- VG4 AutoDome Modular Pipe Mount kit
- VG4 AutoDome Modular Roof Mount kit
- VG4 Pipe Mount Interface Board (VG4-A-9543) without a visible date code stamped as shown in Fig. 3.

1.0 Issue

2.0 Resolution

Figure 1: VG4 Pipe Mount Interface Board showing Epoxy Separation

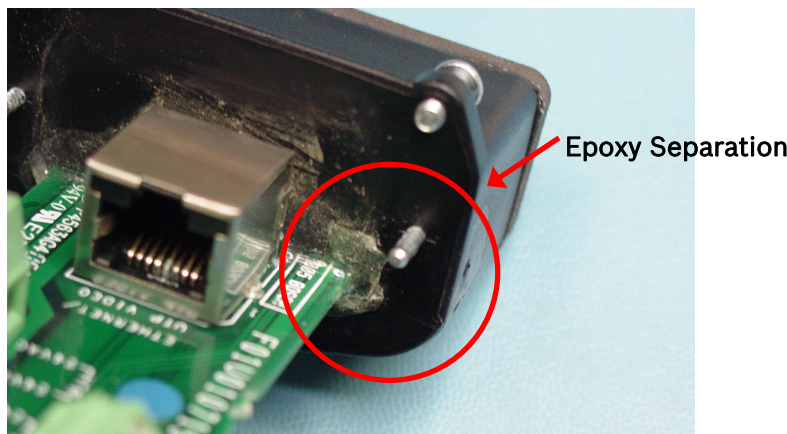
The epoxy that adheres the Pipe Mount Interface Board to the rest of the assembly can fail. This issue may cause the AutoDome to fail and may induce corrosion.

Figure 2: VG4-A-9453 Pipe Interface Board: original design (left) and new design (right)

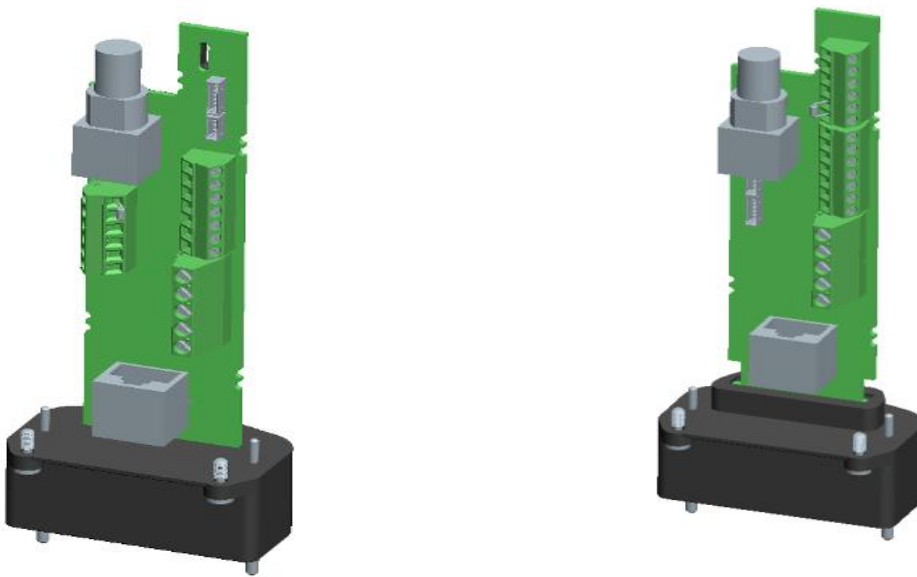
The physical layout of the VG4-A-9453 Pipe Interface Board has been redesigned to eliminate the effects of water inside the pipe. The base of the Pipe Interface Board has been extended to shift the seal location higher in the pipe. This raised seal also prevents the flexing of the board from damaging the seal. This change has been implemented and the new design began shipping in July 2009.

The new design is distinguished with a “blue dot” label on the board and has a Date Code stamped onto the black over mold at the base of the assembly. The Date Code is in the YYWW format, where YY is the 2 digit year and WW is the 2 digit week. For example, the date code 0918 is week 18 of 2009. The original design did not have the raised edge and does not have a date code.
